PCN – Process Change Notification

Change:	WPC.25B.35
Date:	2017/02/03
Author	Haley Tsai

Model#	Part Number	Changes
WPC.25B 2.4GHz Patch Antenna 25*25*4 With MMCX(F)ST	WPC.25B.35	Amend design

Illustration of Change

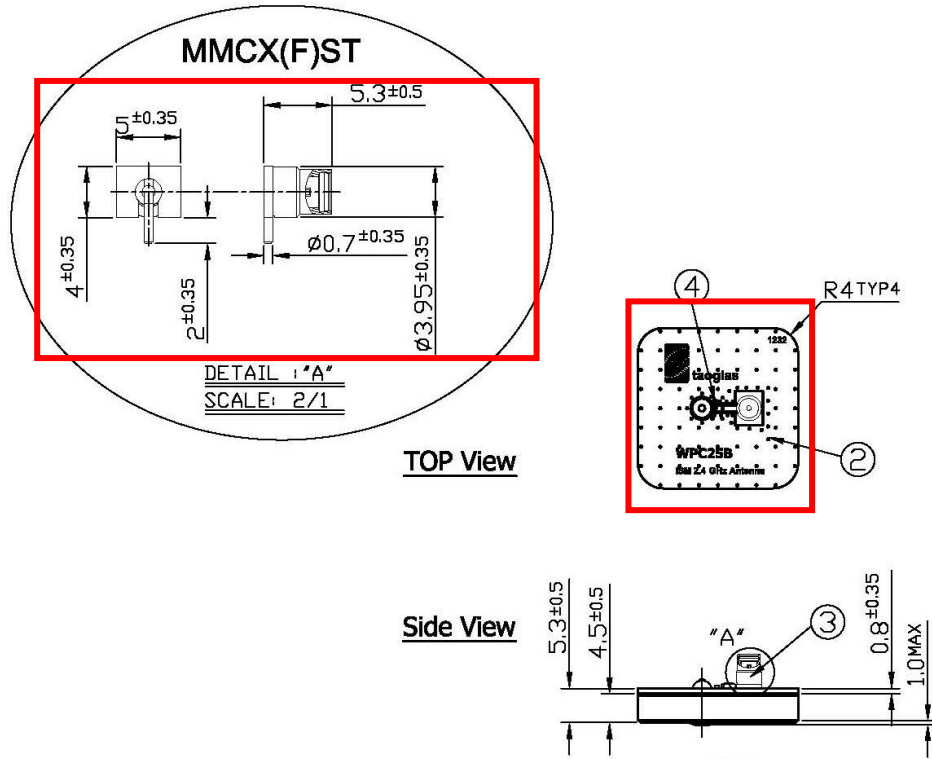
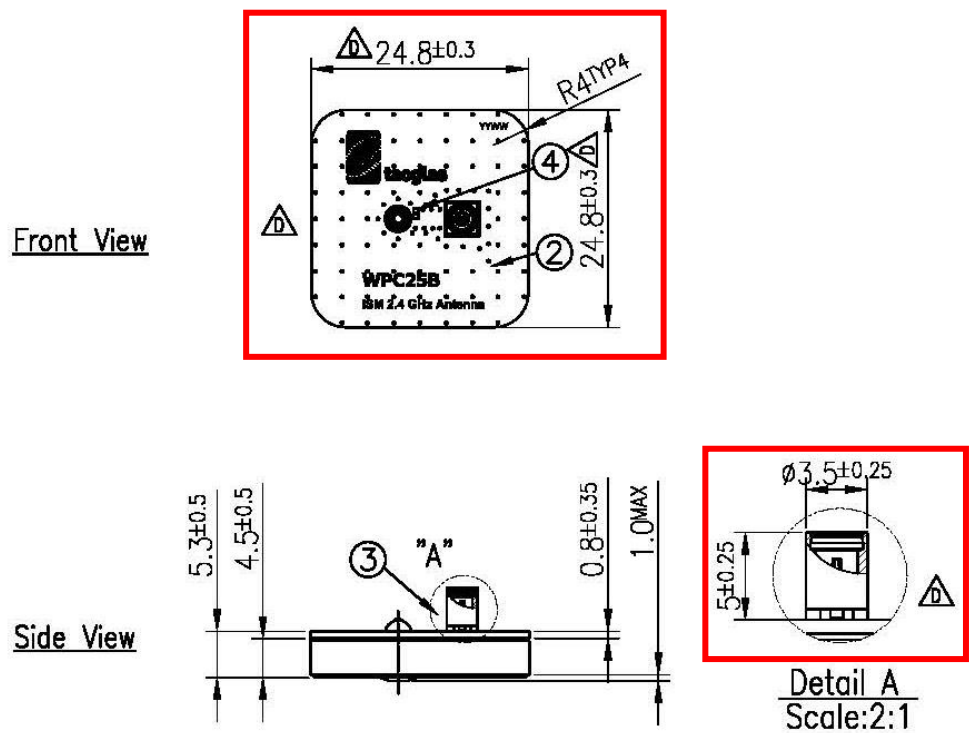
Original design the connector would cause tilted issue when during SMT processes. In order to solve this problem, Taoglas change another connector for this design. Through the experiment, the antenna electric characteristics are not changed, and it obvious solve the title issue. So, we will import the solution into our new production process.
